MCNARY PIT DESIGN CONCEPTS

FFDRWG
7 November 2024

MCN PIT DETECTION PROJECT DELIVERY TEAM

#1 SPILLWAY RESHAPING INSERT

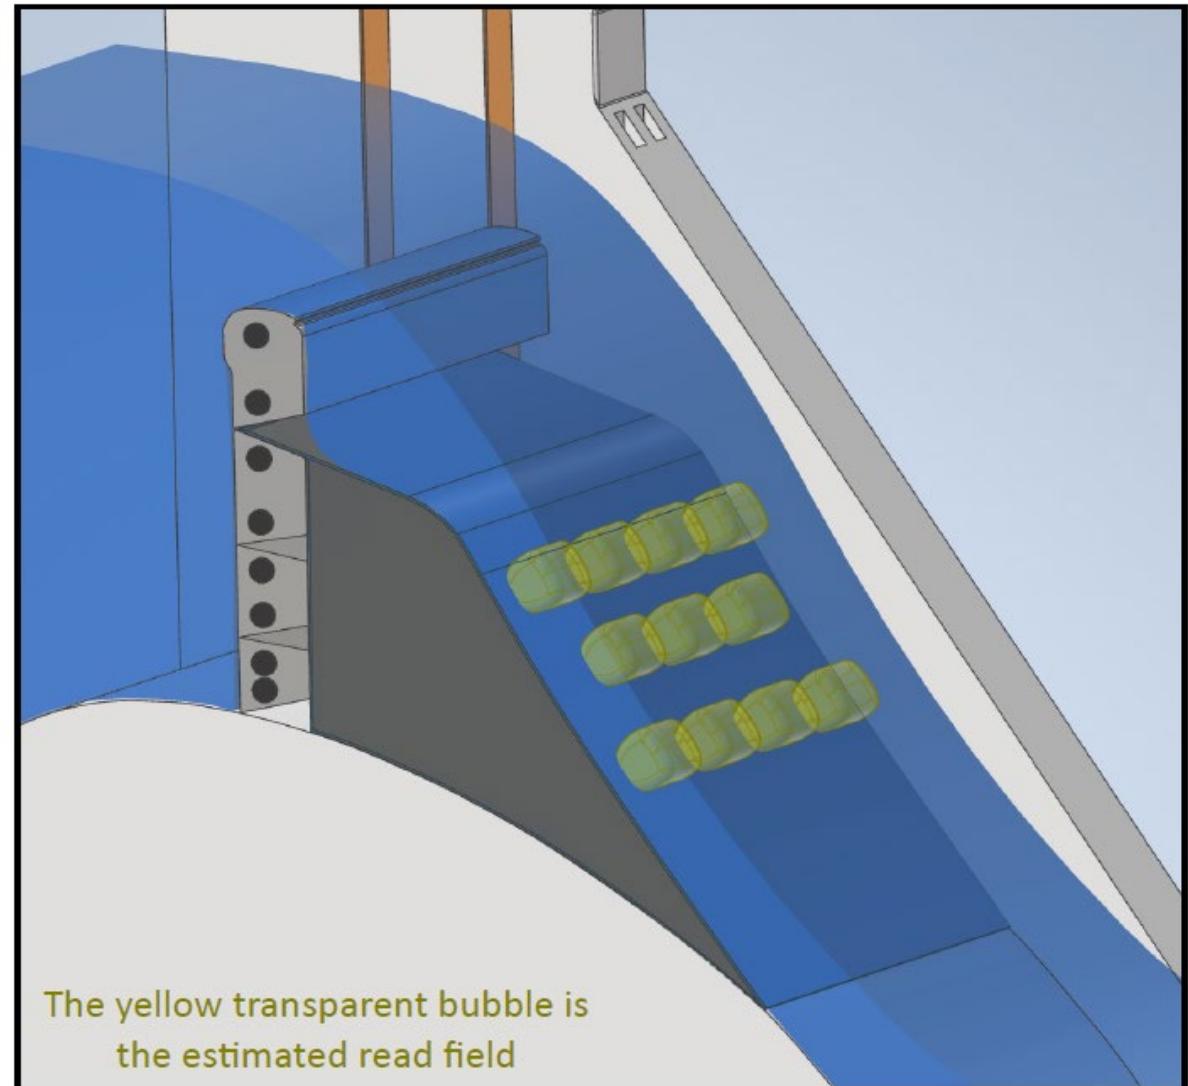
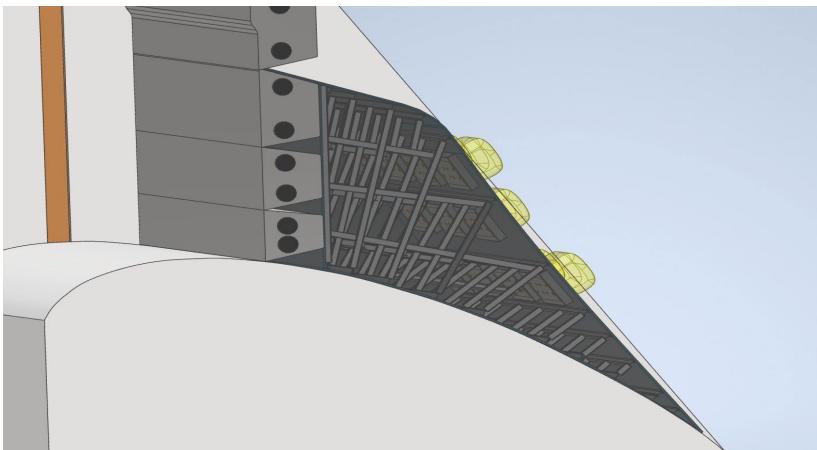
- a. Structural- Constraint- too heavy. Not likely to move the structure with a crane.
- b. H&H- Constraint- not able to impact the PMF (probable max flood)
- c. Civil concern- how to anchor this structure to existing spillway w/o damage
- d. Inspection concern- how would this be inspected
- e. How much time for R&D before this could be implemented? -several years at least
- f. **REMOVED FROM CONSIDERATION**

#2 SKIMMING DETECTION ARRAY

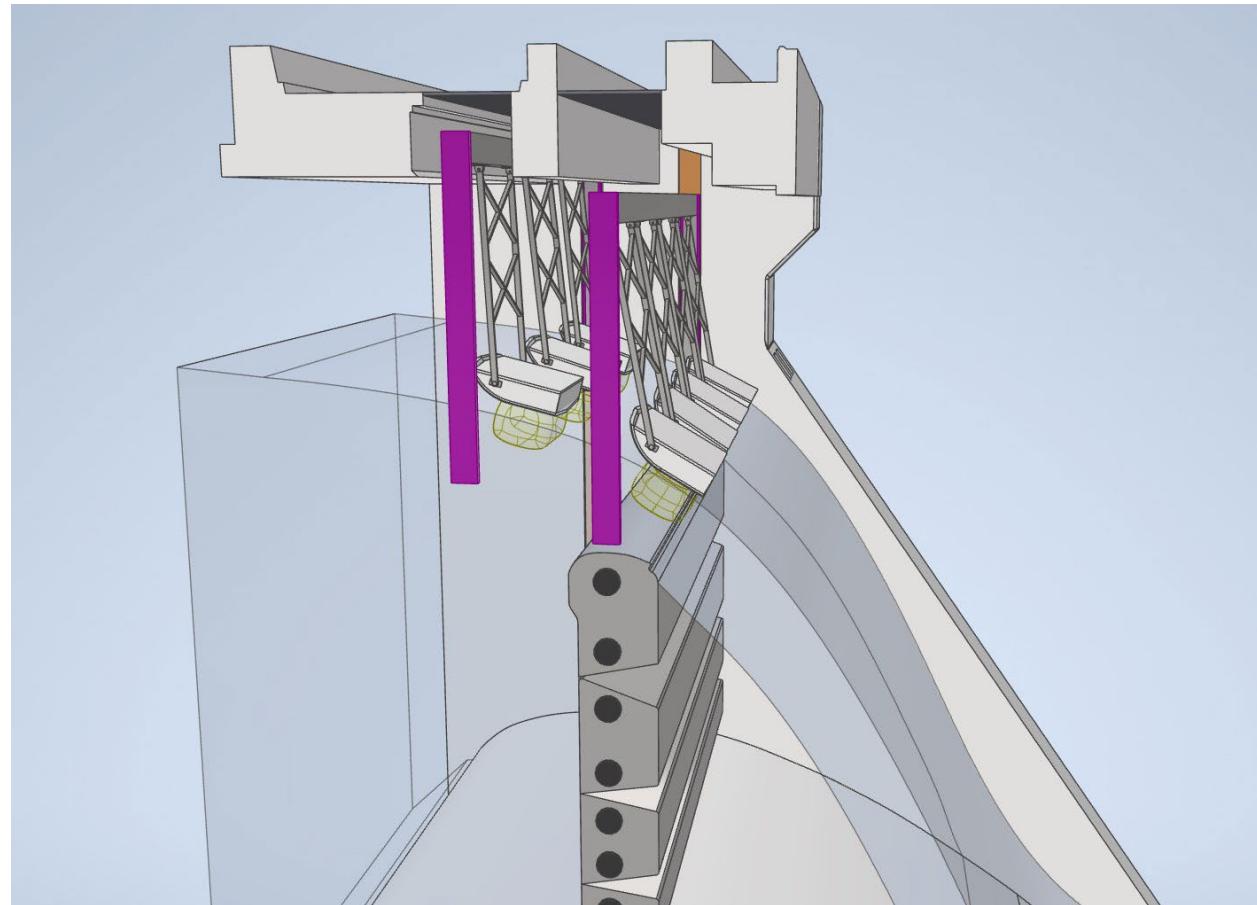
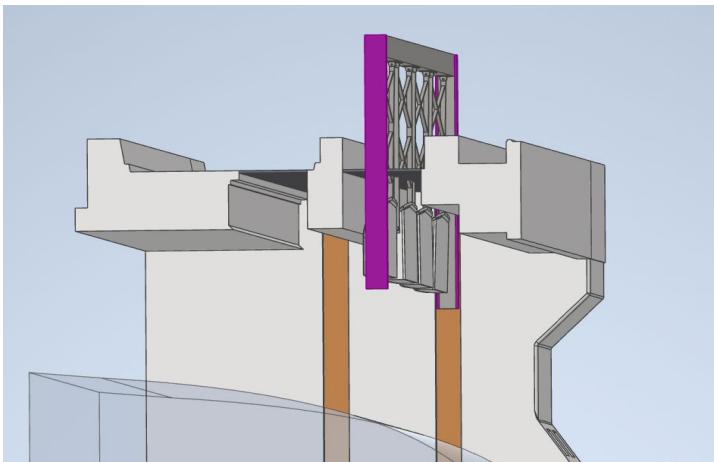
- a. Project Con- Debris; the TSW is the main route debris is pushed through
- b. Fisheries Con- located at surface and fish are not exactly at the surface
- c. Ques: how deep is the water column at the TSW? Ans: 12-14 feet at MOP.
- d. Fisheries Con- detection rates decrease with debris flow
- e. OPS - concerned about day-to-day operations and all the moving parts
- f. All- appears to be high maintenance costs/time

#3 ARTICULATION FIN ARRAY

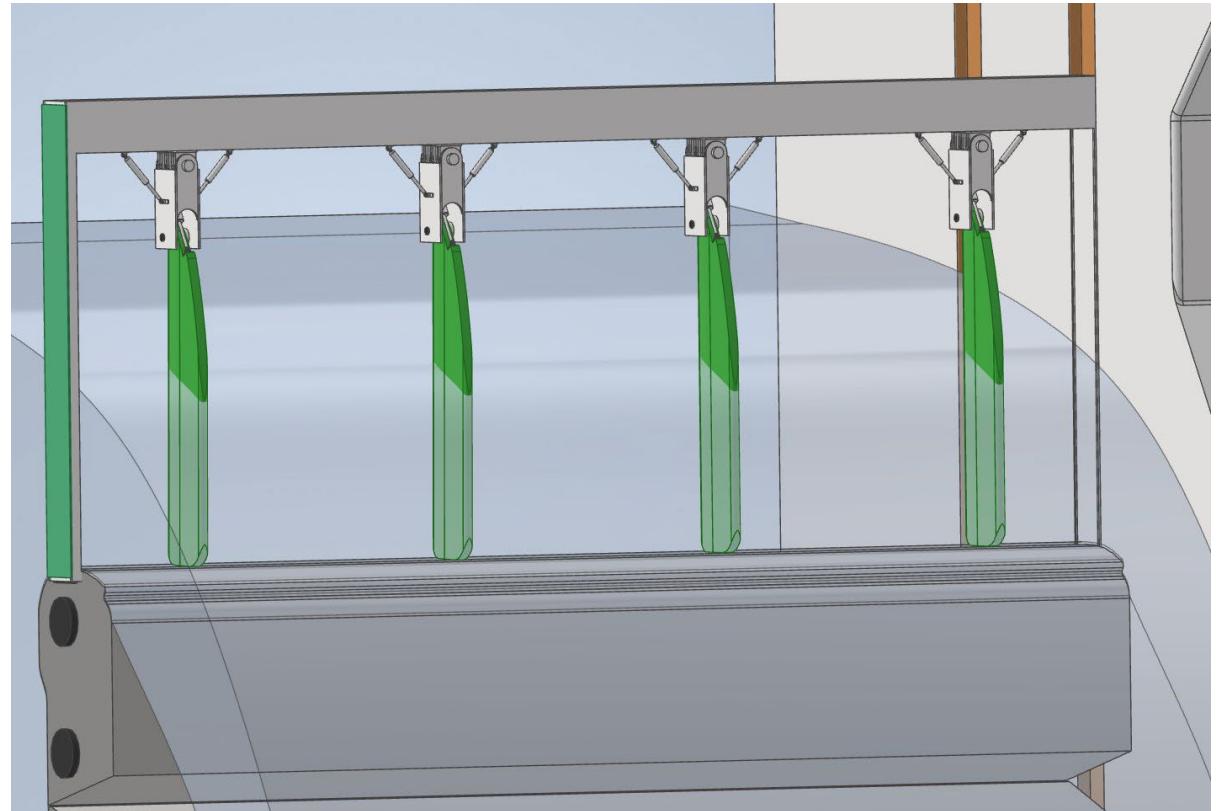
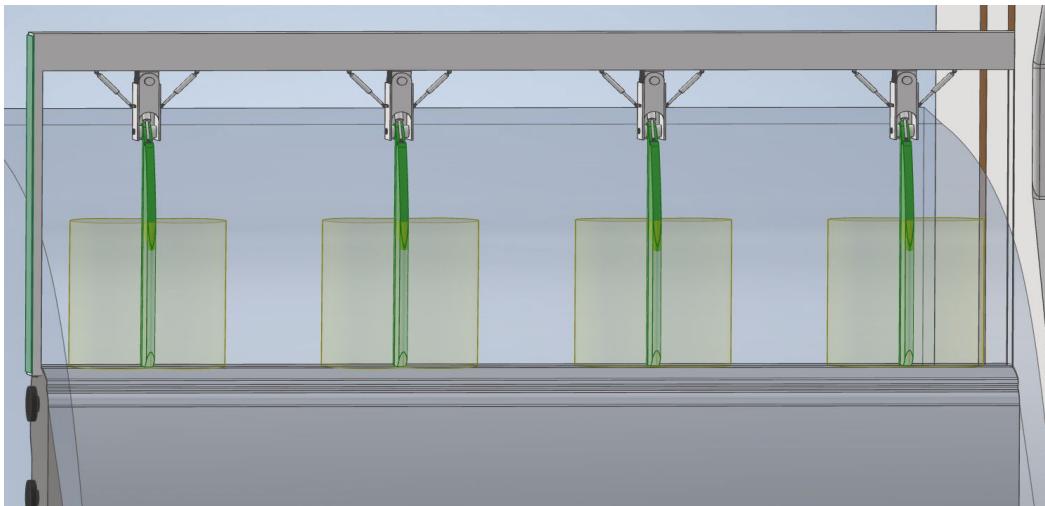
- a. Fin array is flexible- similar points to concept #2
- b. Likely better detection
- c. Elect- **Not enough room to support electrical needs**
- d. Concerned about garbage and debris getting tangled
- e. OPS- concern about the addition of hydraulics- trying to minimize oil spill
- f. More moving parts usually equates to more maintenance and cost over time
- g. **REMOVED FROM CONSIDERATION**

#4 DETECTION EMBEDDED TSW

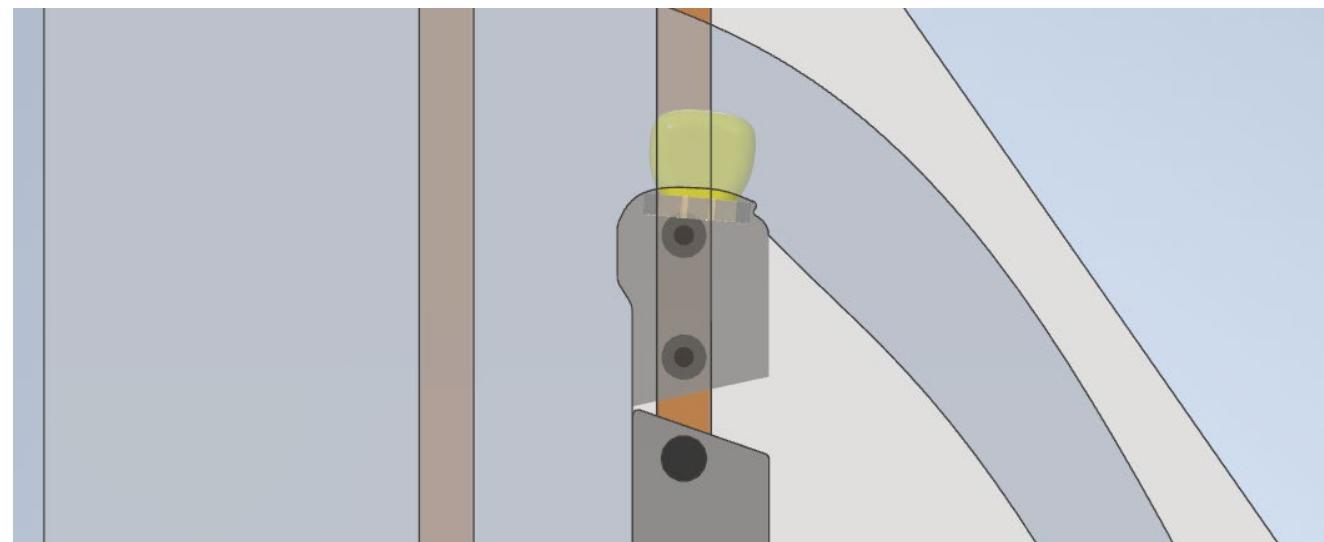
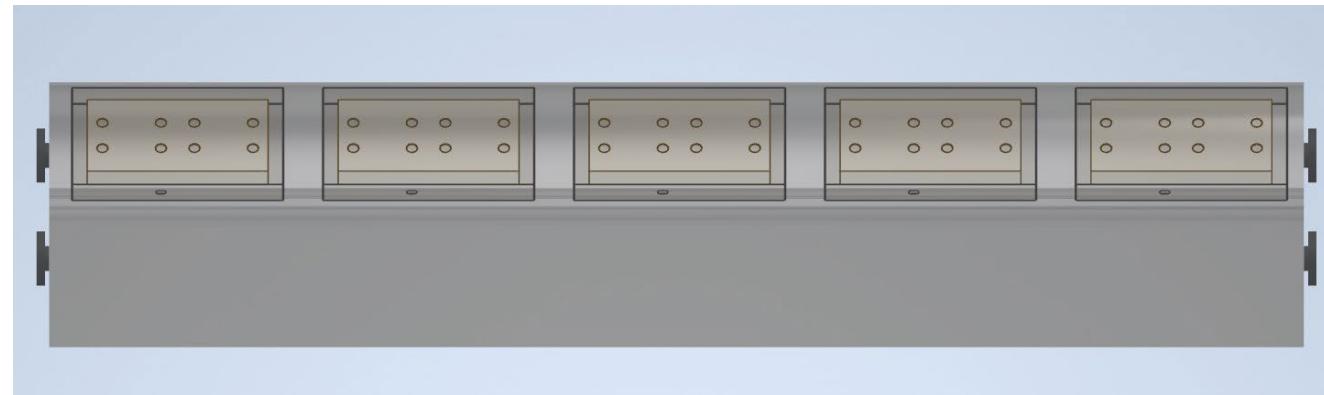
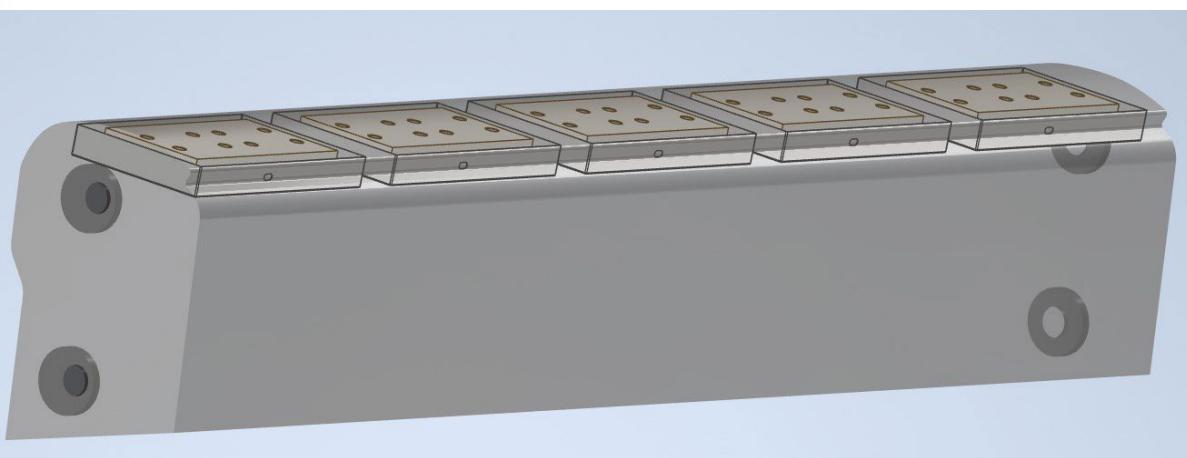
- a. This alternative is favorable to team
- b. Percent detection would be lower
- c. Requires removal of surface of TSW- what did LGR have to do to remove rebar from the concrete and what was the depth embedded?

#5 TSW EMBEDDED PIT TAG FIN ARRAY

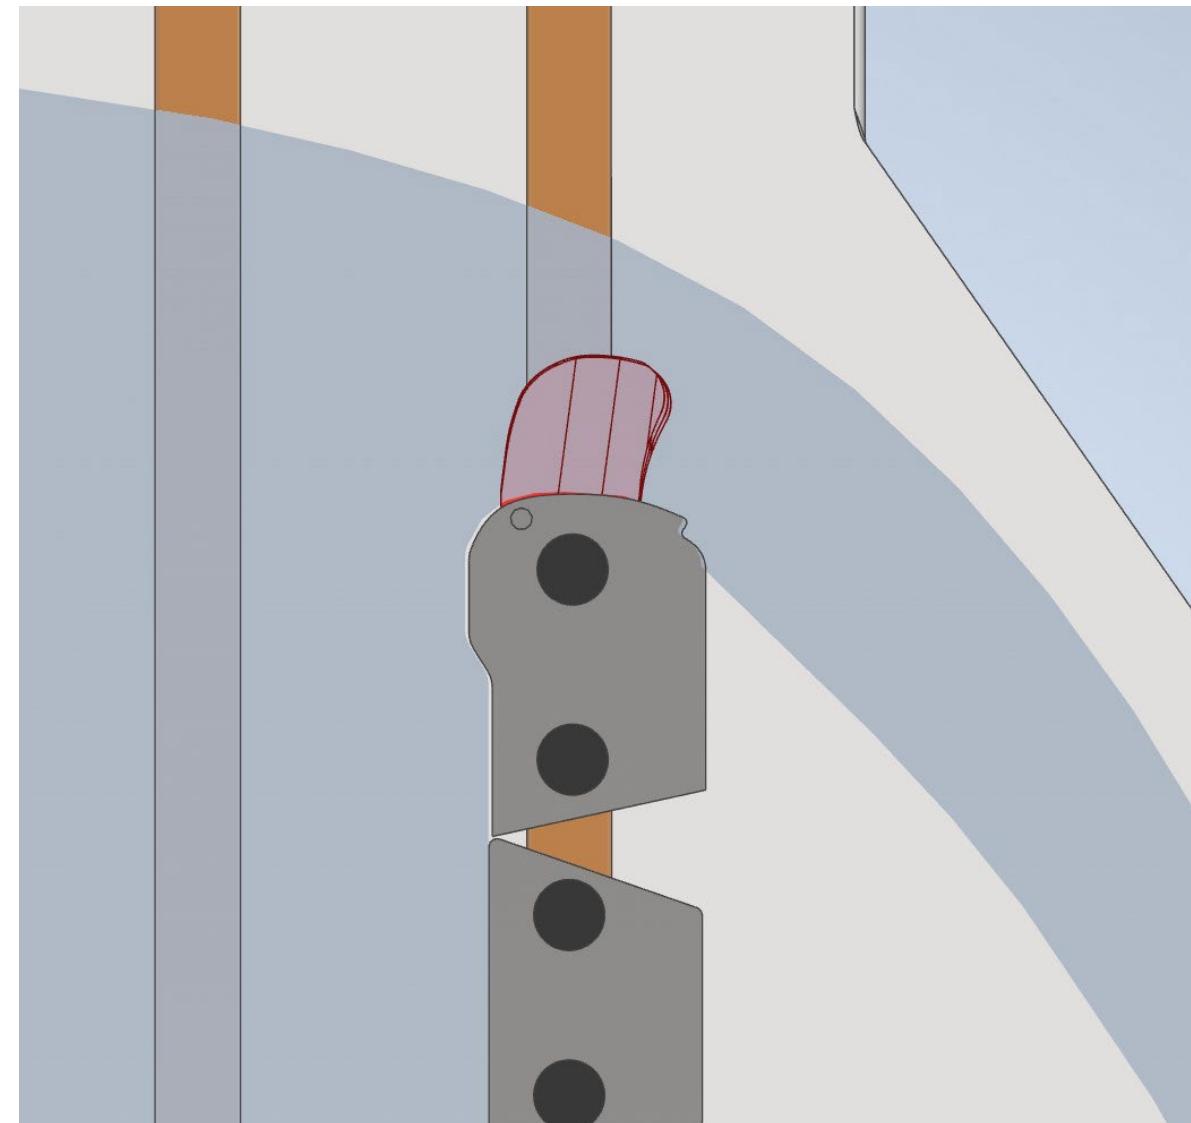
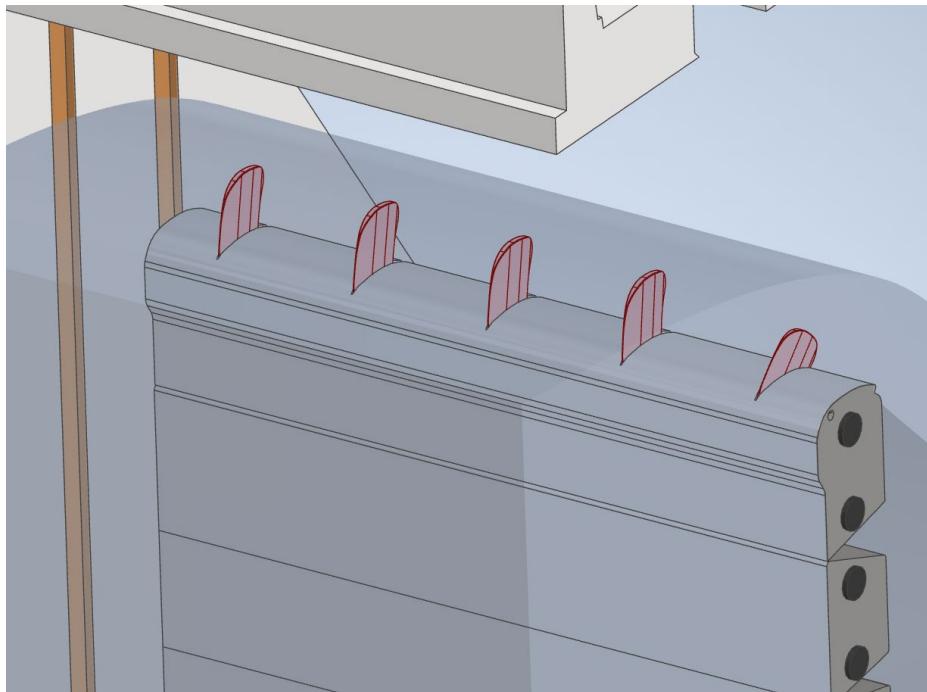
- a. Designed to deflect down
- b. Con- debris getting stuck in slot, garbage, plastics etc.
- c. High-cost maintenance and probability for problems
- d. **REMOVED FROM CONSIDERATION** due to possible fish strikes

#6 EMBEDDED IN THE EXISTING OGEE

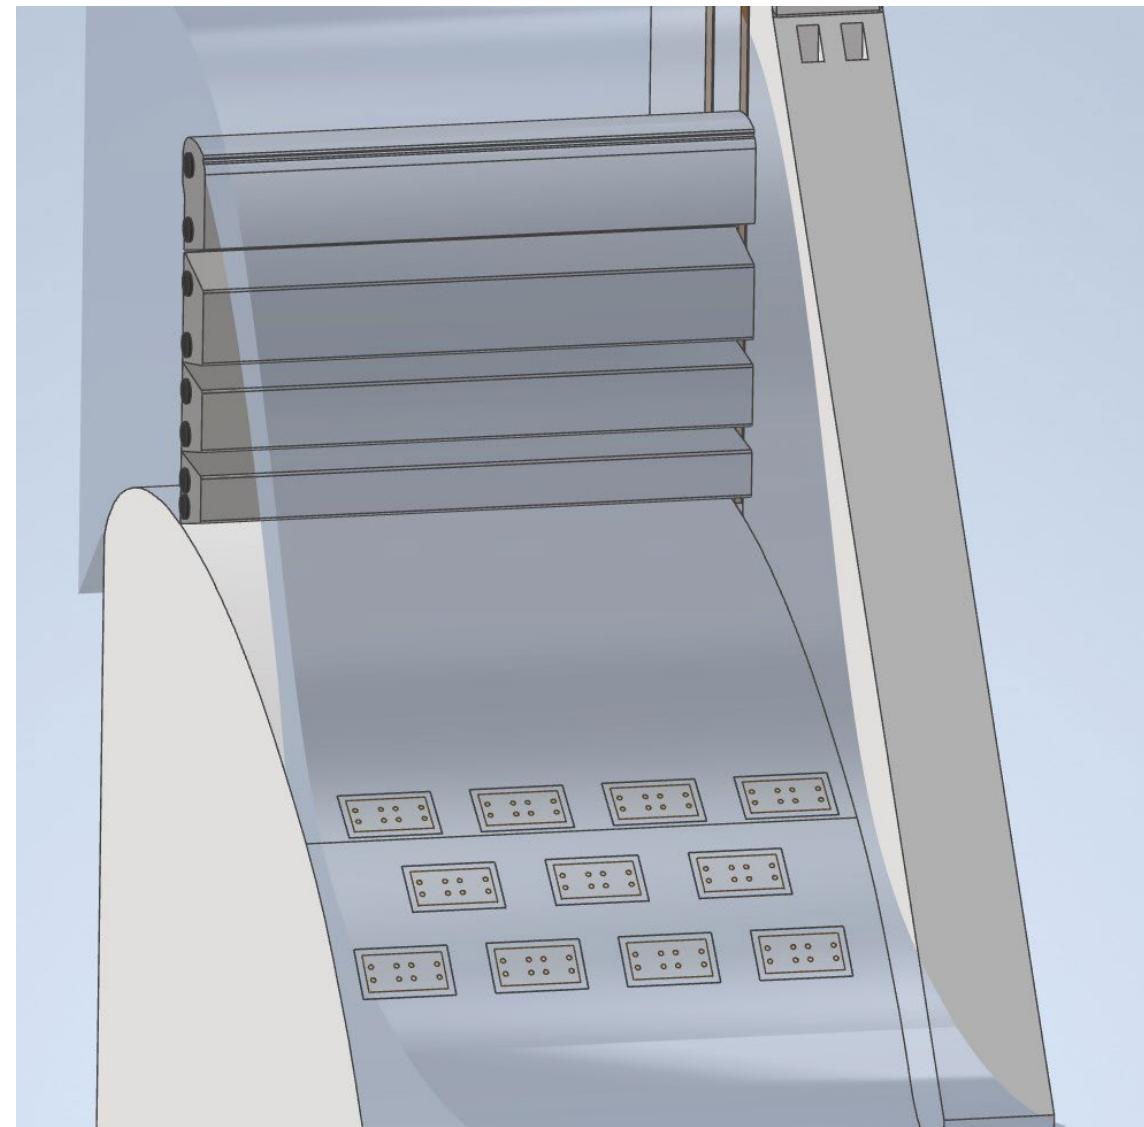
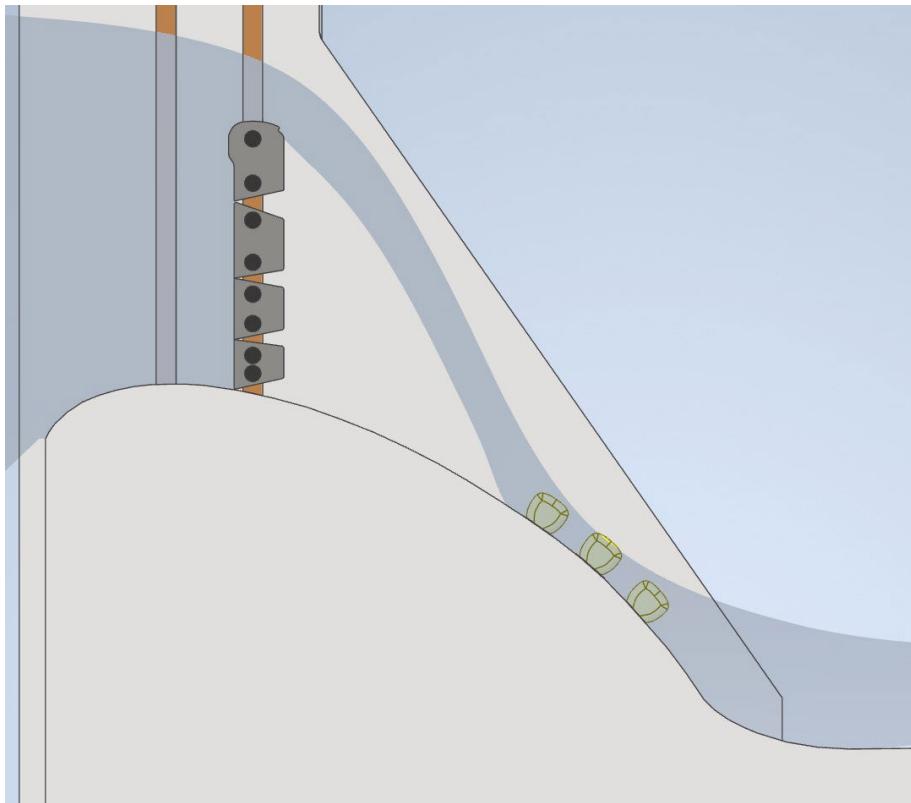
- a. Would need to move TSW to bay 22 to reach electrical
- b. Con- very costly
- c. Not easily replaceable
